MEETING OF November 15, 2011

AGENDA ITEM NO. 5A

Application I.D.: 2011-0006
Application Type: Single Family Design Review
Location: 910 E Street
Applicant: Christian Ruffat
Owner(s): Steve and Shari Wendland
APN: 045-254-120
Zoning: R-1C - Single Family Residential District
General Plan Designation: RL – Low Density Residential
Environmental Determination: Categorically Exempt, Section 15303, Class 3(a)

PROJECT DESCRIPTION

9 Tree Map Scan

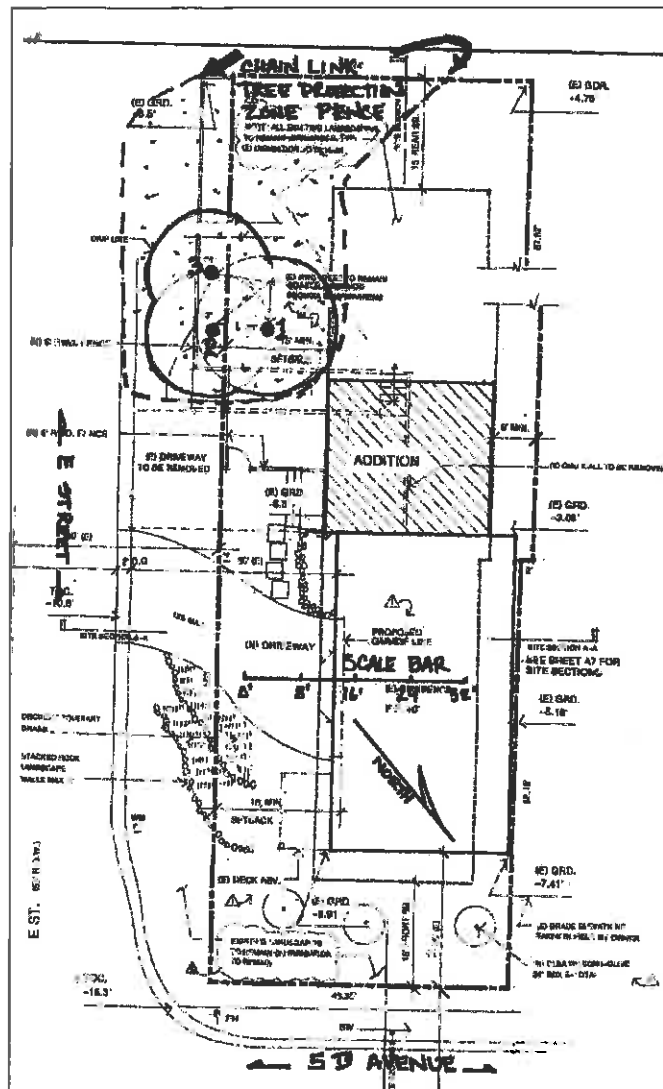
The tree map scan is a marked up version of applicant sheet A1 "schematic site plan" revision date 4/14/11 by Christian Ruffat of San Mateo, California (stamped received City of Belmont Building April 22, 2011). On this sheet the author (contract city arborist or "CCA") drew scaled canopy driplines as solid line, and suggested tree protection zone fencing routes as dashed lines.

Note how the author's proposed tree protection zone fence and wood chip mulched area extends beyond the existing wood property boundary fences into the open soil root zone areas of the driveway edge and the street, and are designed to optimize root survival and root health for all 7 rear yard coast redwood trees throughout the construction process.

10 Site Photographs

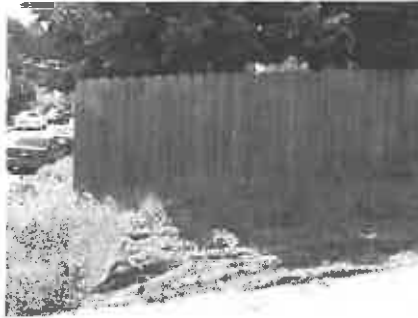
View of the existing CMU block wall as viewed looking up the driveway.

The south side of the driveway has an open soil strip that will become part of the chain link fenced root protection zone.
